REQUEST FOR COUNCIL ACTION

Item Description: Request for Approval of a Preliminary Plat of the Residential Property at 2201 Acorn Road into 4 Lots

REQUEST FOR PLANNING COMMISSION ACTION

Item Description: Request for approval of a preliminary plat at 2201 Acorn Road (PF15-010)

OAK ACRES
ROSEVILLE, MINNESOTA
GRADING, DRAINAGE & EROSION CONTROL PLAN

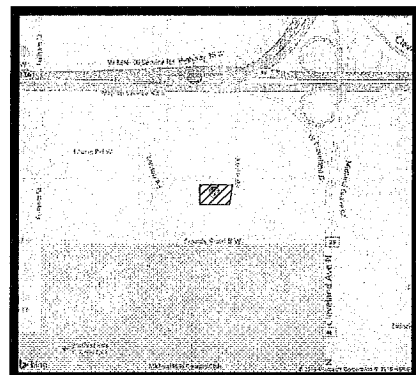
- a. There are several small basins shown to address the required storm water treatment and retention requirements. The overflow of these devices for the most part appears to flow to the rear of the development and ultimately drain to the existing catch basin located between this parcel and Marion Street to the west. While overland flow is an acceptable method of conveyance for storm water, the existing undulating ground in this area currently slows water conveyance and causes some pooling of water during heavy events. This will continue to be the case after development, although the proposed basins should provide some rate control for most rain events.

Regarding the grading plan and tree preservation plan, Mr. Boryczka questioned how the Oak tree drip lines would suffice, opining most of those trees would die. Further, Mr. Boryczka addressed the swale drainage proposed to flow to the southwest corner of the property, which had never changed in the many variations proposed for this subdivision, opining that it will drain off onto someone else's property as the proposed ponds will absolutely not hold the stormwater runoff. Given his expertise in the field of stormwater drainage, Mr. Boryczka further opined that the runoff would not stay in those areas due to their depth.

Member Bull questioned if the basins surrounding the private street were intended to take care of the height of the property and street, but questioned whether impacts would not be found from dropping elevations and hard cover from new residences and their driveways.

121
122 At the request of Chair Boguszewski, Mr. Culver stated that this project, as currently
123 designed, would not make the current drainage situation any worse, but clarified that
124 during a heavy rain event, these devices would get overrun. However, the way
125 they're set up, Mr. Culver stated that they will drain over and down, but he could not
126 guarantee there would be no additional drainage to the north of the site because of
127 where future roof drains may be pointed and additional impervious surface being
128 added. Using rain event experienced during the summer of 2015, Mr. Culver opined
129 that with this proposal it would have provided better conditions than currently exist.

Public Works Director and City Engineer Mark Culver responded that the numbers stated by Mr. Ramalingam were essentially correct and comparable to his calculations resulting from additional impervious surface with this proposed project and as noted in his summary drainage report. While the basins appear to be shallow, Mr. Culver clarified that they were designed to be shallow as they were constructed with engineered soil that served as a holding cap not just for depth of the depression, and advised that the total actual depth of the engineered soil and the depth of the ponds or depression provided sufficient holding capacity. However, Mr. Culver agreed that they were most likely not going to hold all the water from large rain events, if similar to the intensity of those rains experienced this summer, but opined that from his recollection of his calculations believed that the design of the ponds would hold that water or slow down the runoff so it didn't leave the project site. Mr. Culver noted that the water would eventually leave the site by infiltrating through soils even though that is not the preferred mitigation.
